Amendment No. 0003
14 June 2002

SUBJECT: Amendment No. 0003 to Specifications and Drawings for Construction of
Perry Creek Flood Protection, Phase 4, Sioux City, IA
Solicitation No. DACW45 02 B 0017.

Am # 0003
Sheet C8.02

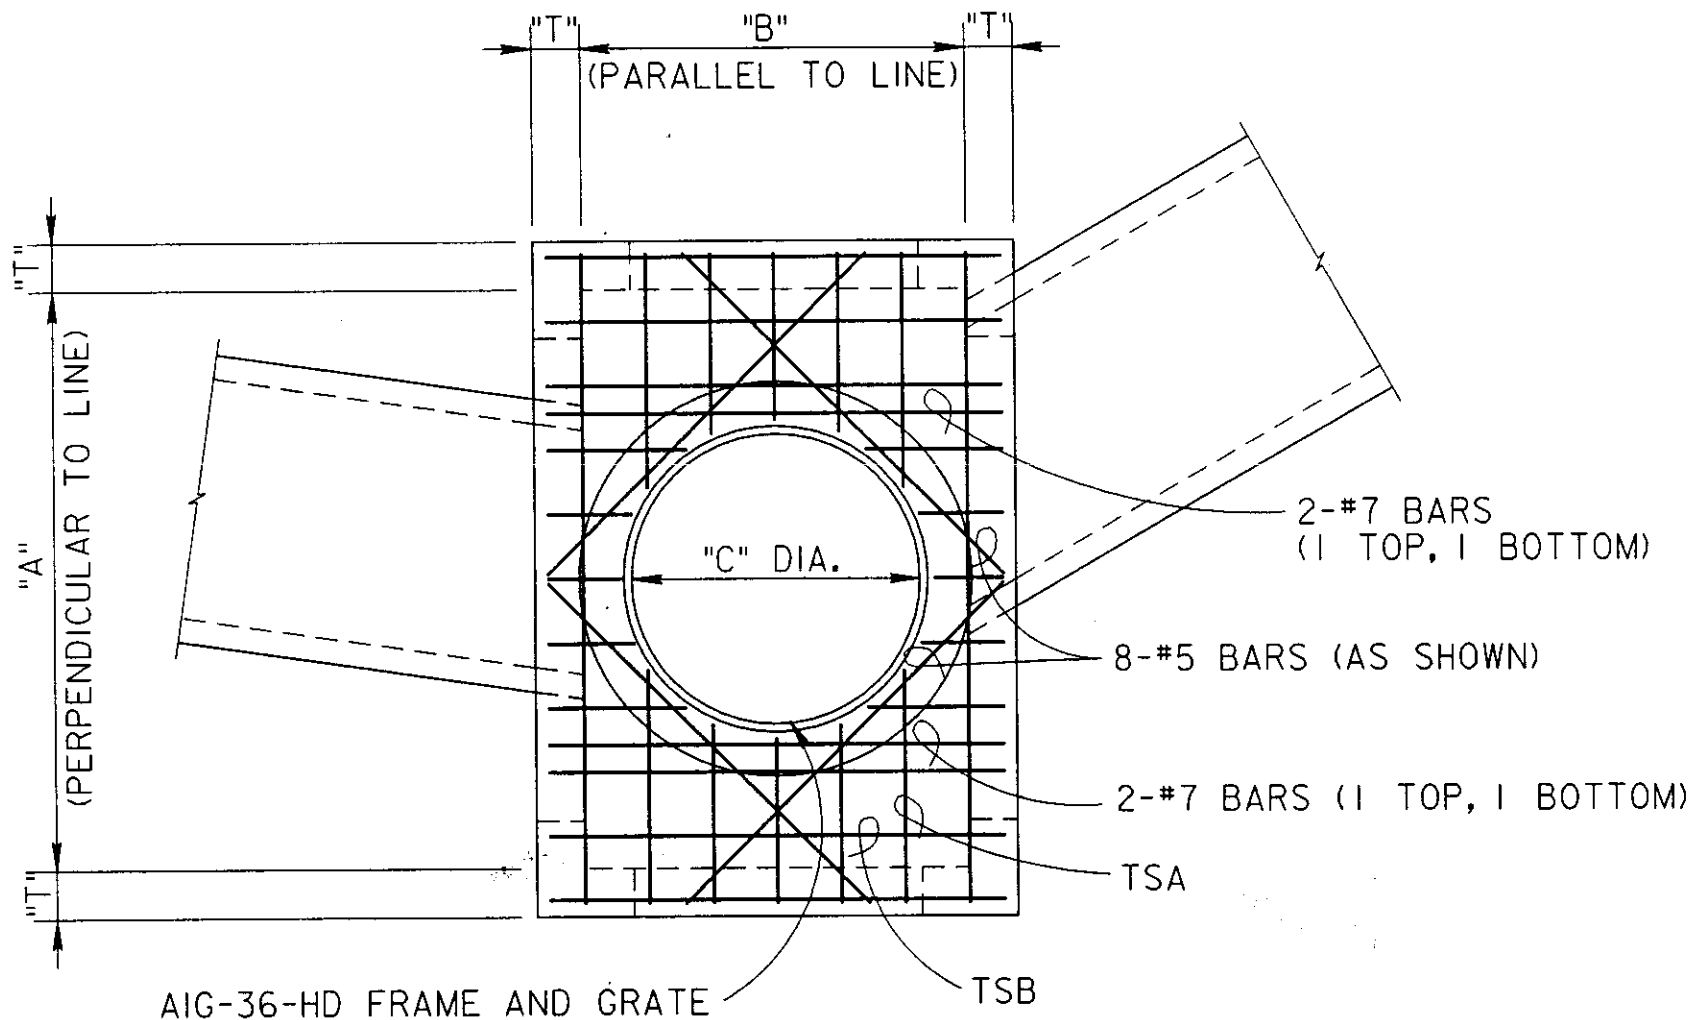
- (1) Sheet C8.02,
 - a) Revise the Area Inlet Data Schedule as shown on the attached partial sheet.
 - b) Add the new detail "A & B NOT EQUAL (SINGLE) TYPICAL PLAN VIEW, to the sheet as shown on the attached partial sheet.
- (2) Sheet C8.09, revise the Storm Drain Schedule as shown on the attached partial sheet.
- (3) Sheet S-10, revise the Hamilton Boulevard Bridge Left Bank Retaining Wall Stationing detail as shown on the attached partial sheet.
